Technical Information

Air Conditioner

CS-E9BKP
CS-E12BKP
CS-E9CKP
CS-E12CKP

Subject : Fan Motor Ball Bearing Noise

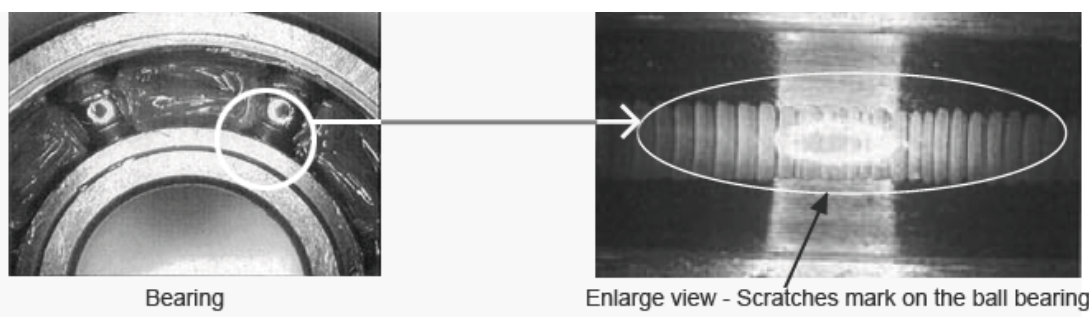
Electro-Chemical Corosion occurs that current flows periodical through ball bearing and creates sparks (wave like abrasion) to the surface.

The defective bearing (at longer shaft side) found a wave line scratch patterns on the bearing wheel surface.

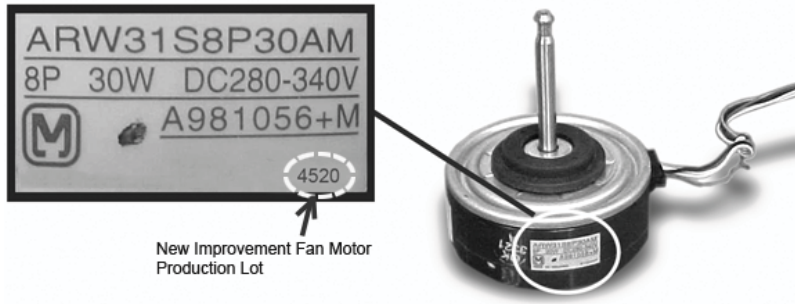
Replace a new improved indoor fan motor of double washer bearing.

Model	Part Name		Remarks
	Original Fan Motor Part Number	New Improved Fan Motor Part Number	
CS-E9BKP	CWA981056	CWA981056	Production Lot: 4520 onwards
CS-E12BKP	CWA981056	CWA981056	Production Lot: 4520 onwards
CS-E9CKP	CWA981056	CWA981056	Production Lot: 4520 onwards
CS-E12CKP	CWA981056	CWA981056	Production Lot: 4520 onwards
